**STAFF RECOMMENDATION**

**2715 Brightwood Avenue**

**October 19, 2016**

**Application:** New construction – outbuilding; Setback determination  
**District:** Belmont-Hillsboro Neighborhood Conservation Zoning Overlay  
**Council District:** 18  
**Map and Parcel Number:** 11704042000  
**Applicant:** Stone Oak Builders  
**Project Lead:** Sean Alexander, sean.alexander@nashville.gov

PROPOSED SITE PLAN  
 LOT 116  
 FINAL PLAT LOTS 116 & 118  
 MAP OF BELMONT TERRACE  
 PLAT INST. 20160719-0074024 R.O.D.C., TN  
 TAX PARCEL: 117.040 420.00

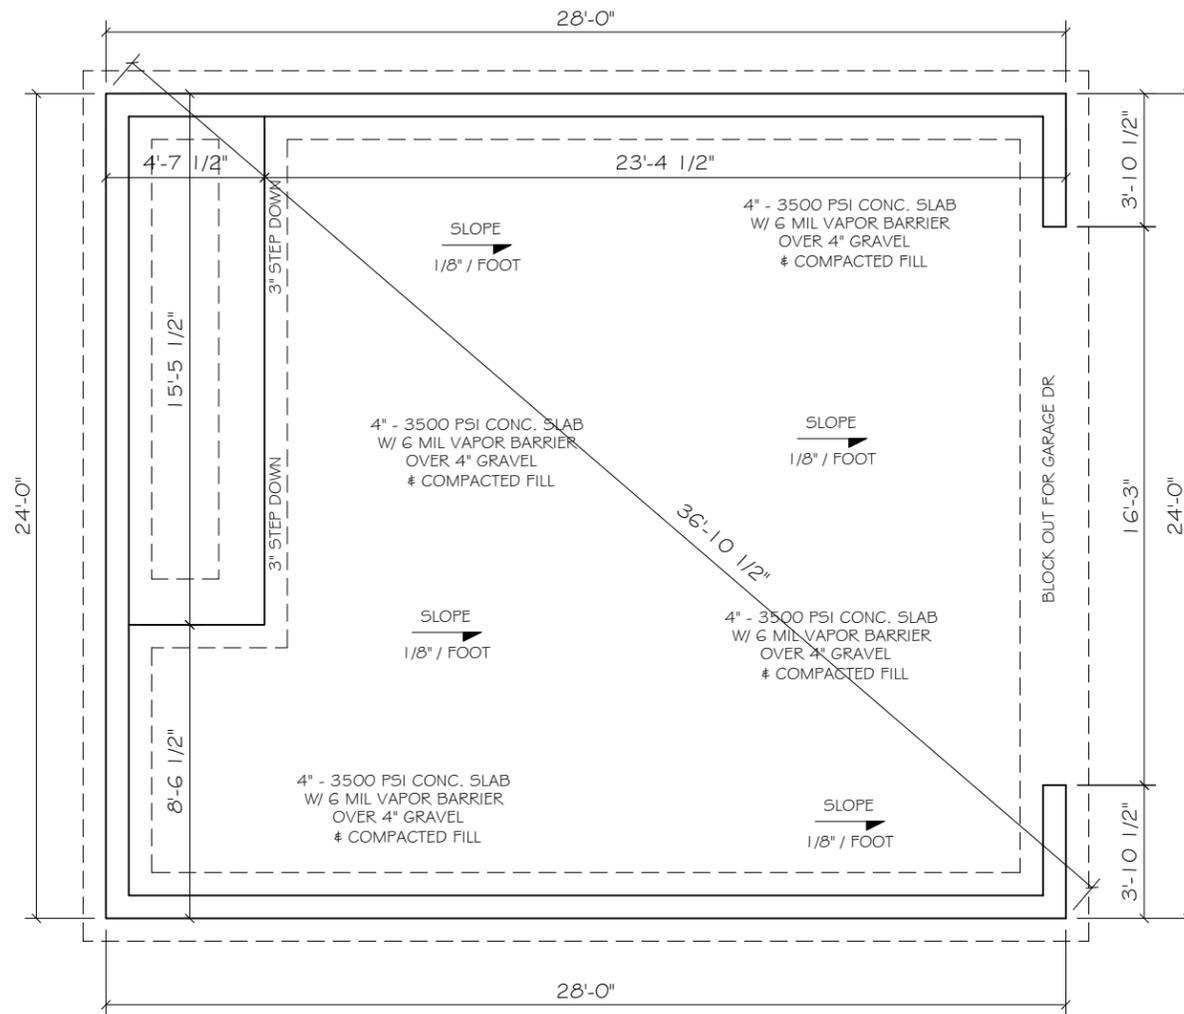
Site Planning & Setbacks: The new outbuilding will be located behind the principal building, with vehicle access coming off of the alley. This location is typical of outbuildings historically, but the proposal will require a rear setback determination.

The base zoning would require the proposed outbuilding to have setbacks of ten feet (10') from the property lines facing the side street and the alley to the rear. The applicant requests setback determinations for the building to be located five feet (5') from rear of the property. The Commission can approve shorter setbacks if doing so would be more appropriate. Staff finds that the shorter setback would be compatible with the locations of outbuildings historically in this location.

Staff finds the proposed setback to be appropriate and that the project meets section II.B.1.i.2 of the design guidelines.

**FRONT ELEVATION**  
3/16" = 1'-0"

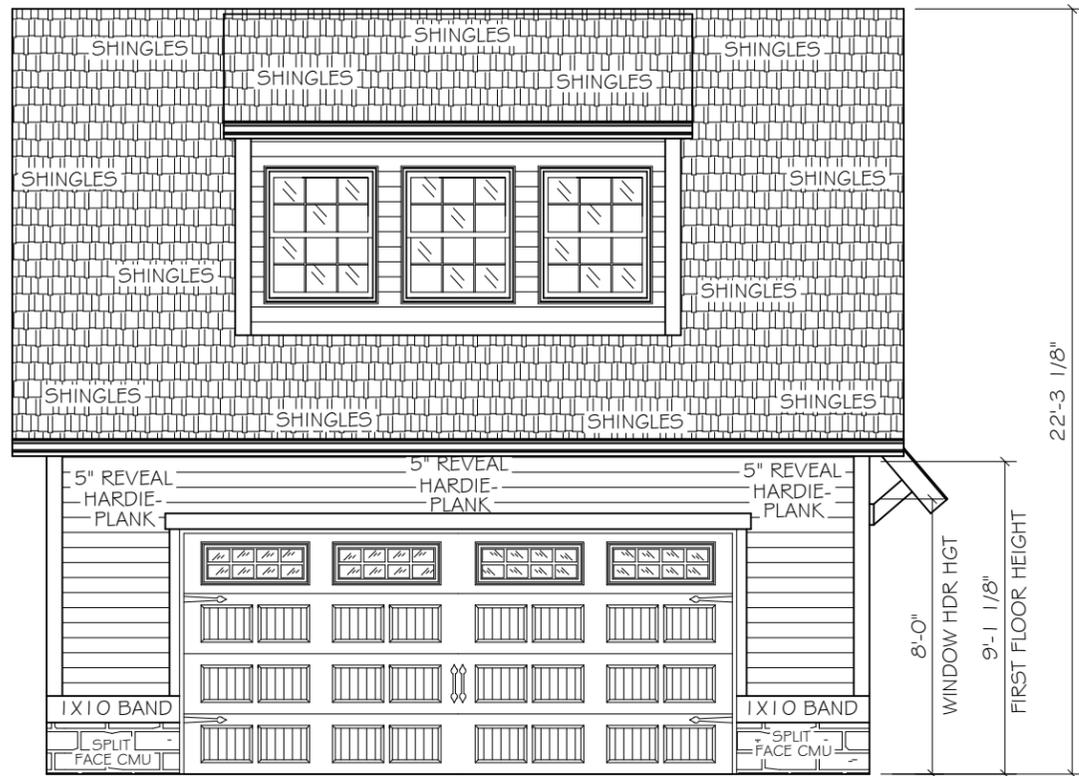
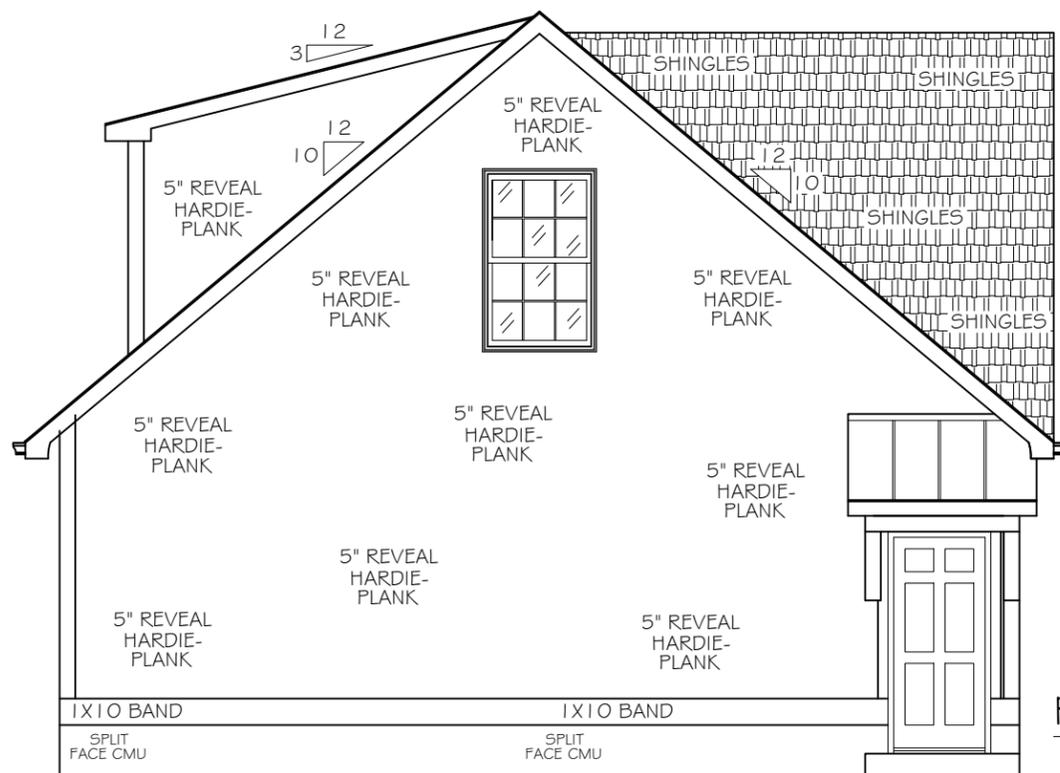
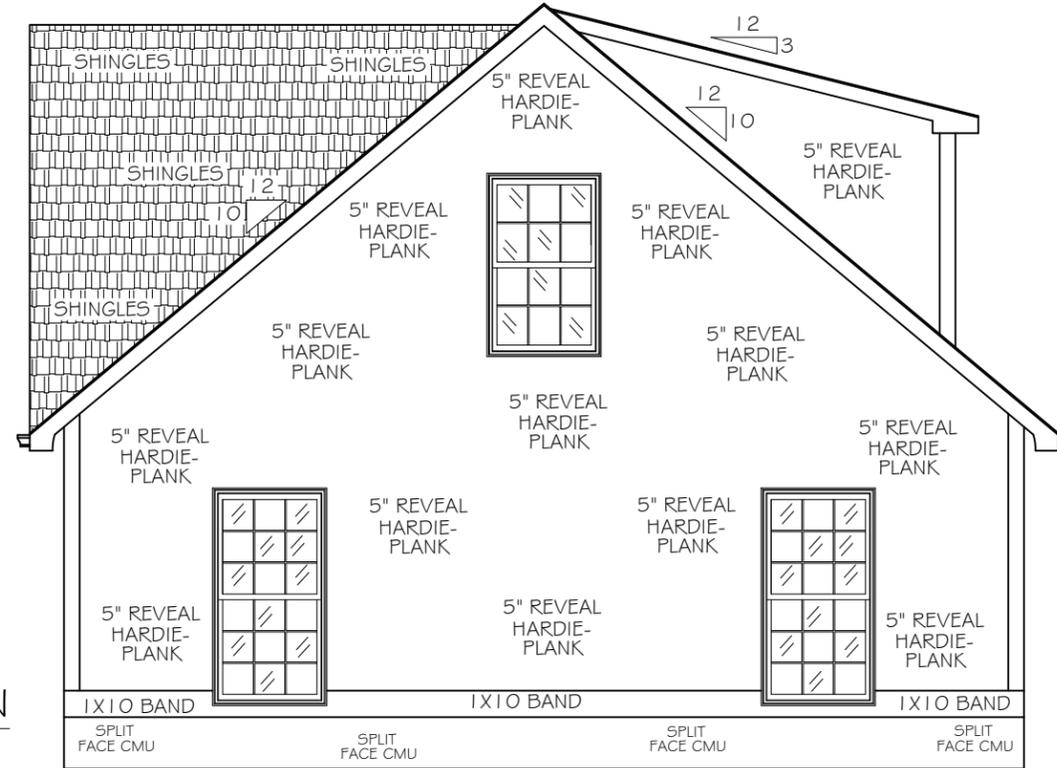
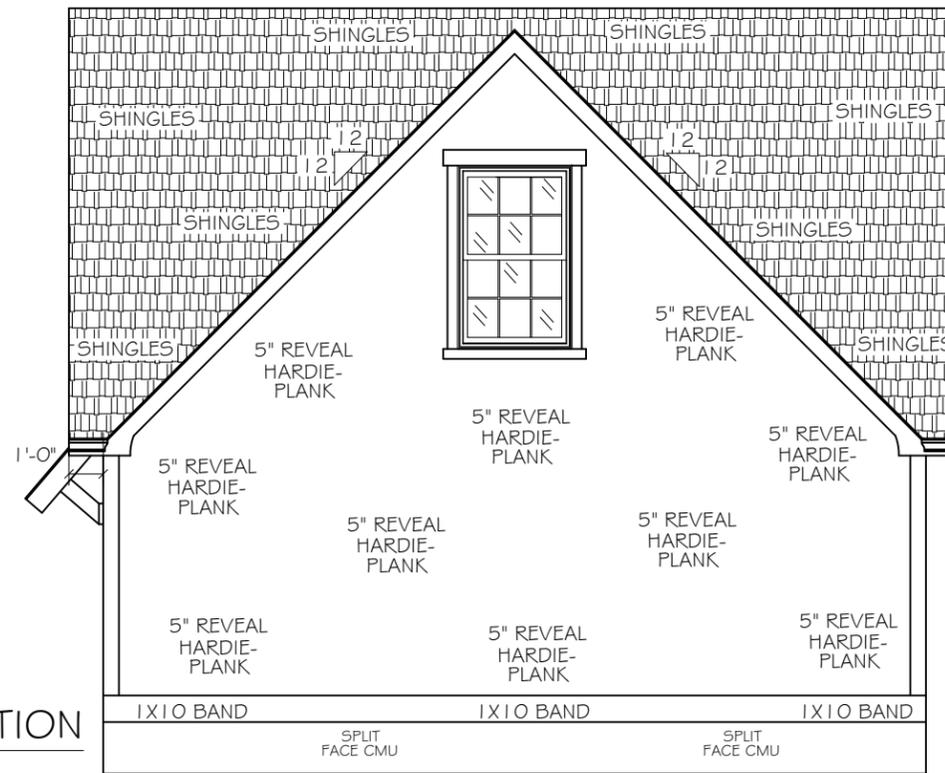
Design Standards: The building will have a one and one-half story side-gabled form, similar to that of the approved principal building. The overall character of the building will be compatible with the principal structure and will meet section II.B.1.i.1 of the design guidelines.

The roof of the building will have a side gabled roof with a shed dormer on the rear slope. The forms and pitches of the roof are typical for outbuildings in the surrounding

1. The window and door selections shall be approved by MHZC Staff prior to purchase and installation.
